CITY OF STAR

LAND USE STAFF REPORT

FP-23-19, Final Plat, Naismith Commons Subdivision Phase 7 FILE(S) #:

FINAL PLAT REVIEW

NAISMITH COMMONS SUBDIVISION NO.	1

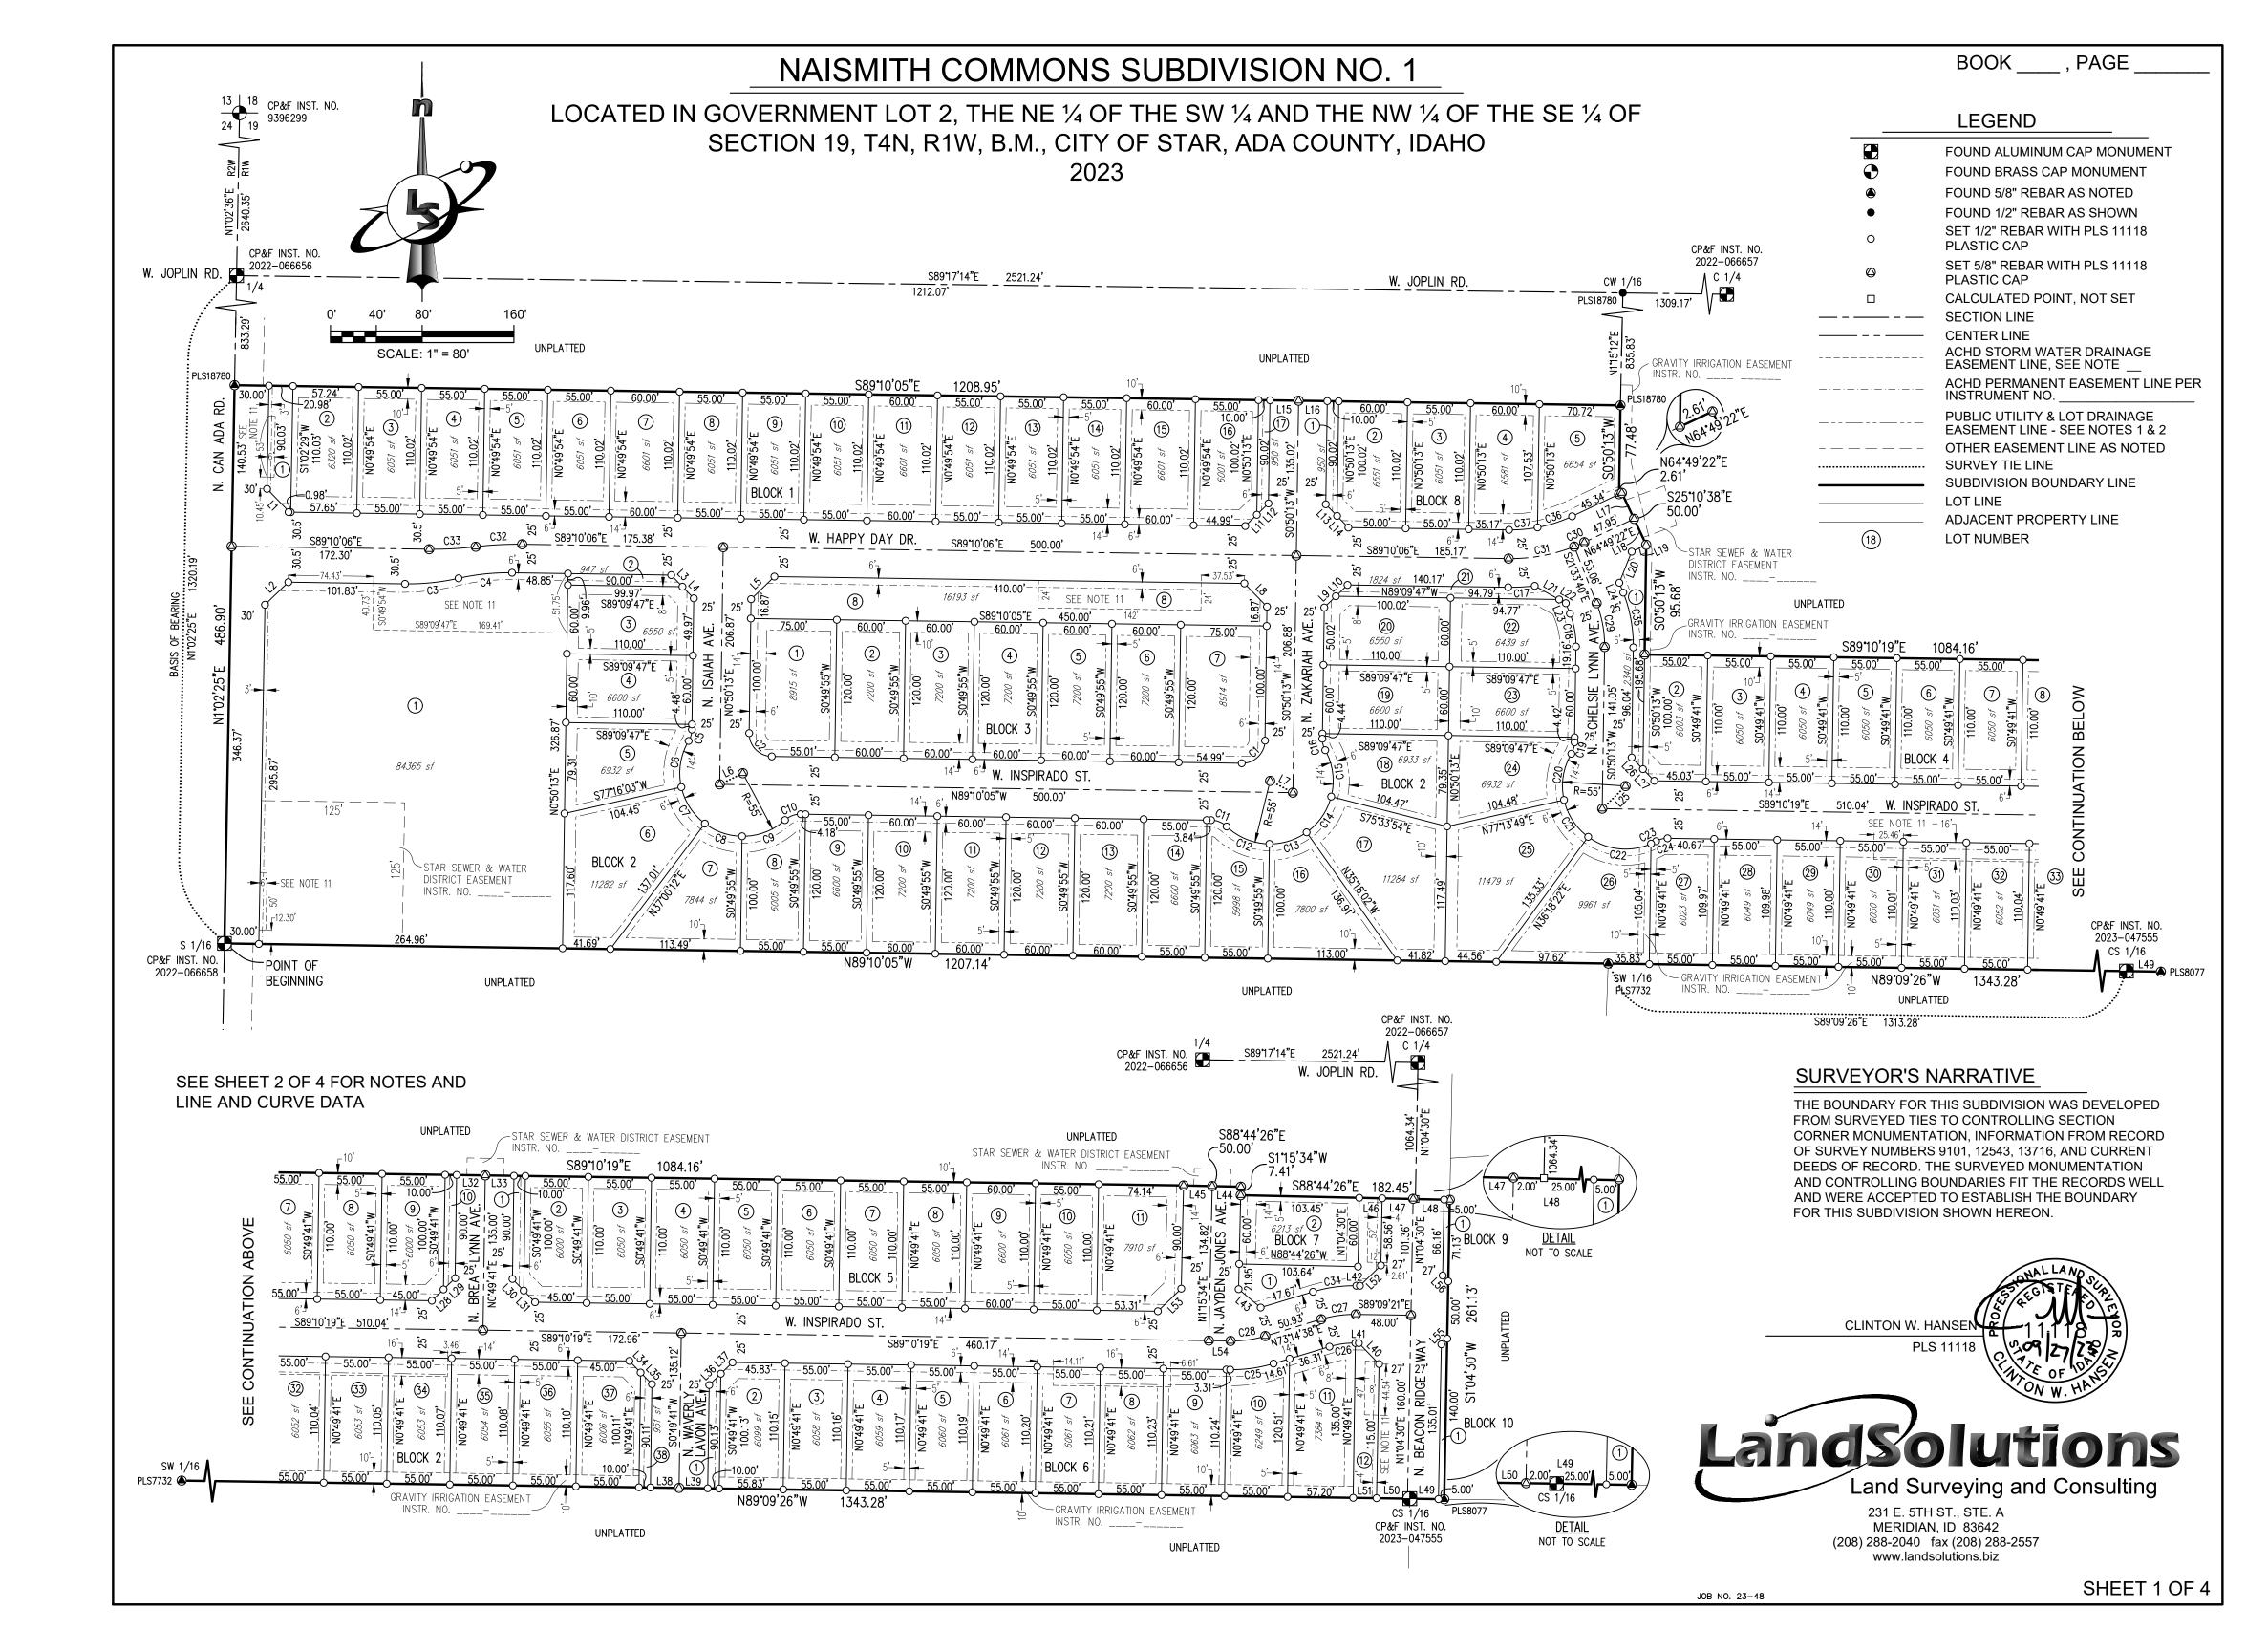
The north-south collector roadway (Beacon Ridge Way), located on the eastern side of the phase shall be revised to show 10' minimum common lots (Lots 1, Blocks 9 & 10) adjacent to the eastern property line. The roadway shall include a detached, 7' sidewalk on both sides. The Applicant may decrease the common lot on the western side of the collector by 5 feet to accommodate the addition to the east. A revised final plat shall be submitted for review.

Can Ada Road shall have 7' detached sidewalks. A revised final plat shall be submitted for review.

9			x	Note on face of plat: "This subdivision is located within zone XX as shown on the firm panel ###, City of Star, Ada County, (or Canyon County?) Idaho and Incorporated Areas. A building permit shall not be issued for any lot that is located within the mapped floodplain until a Flood Plain Development Permit is obtained for the individual lot. Each lot within the mapped floodplain shall require an individual Flood Plain Development Permit."
10				10-foot utility and irrigation easements are shown, or noted, along the front lot lines, rear lot lines, and side lot lines as required.
11		X		Note is shown on the final plat: "Minimum building setbacks shall be in accordance with the City of Star applicable zoning and subdivision regulations at the time of issuance of individual building permits or as specifically approved and / or required, or as shown on the this plat." Revise note 5 of the plat

• Increase Lot 1 Block 9 and Lot 1 Block 10 from 5 feet to 10 feet in width, thereby reducing the width of Lot 1 Block 7 and Lot 12 block 6 from 20 feet to 15 feet. All other configurations may remain.

- Sidewalks on both sides of Beacon Ridge shall be 7-foot-wide detached walkways.
- Sidewalk on CanAda shall be 7-foot-wide detached walkway.
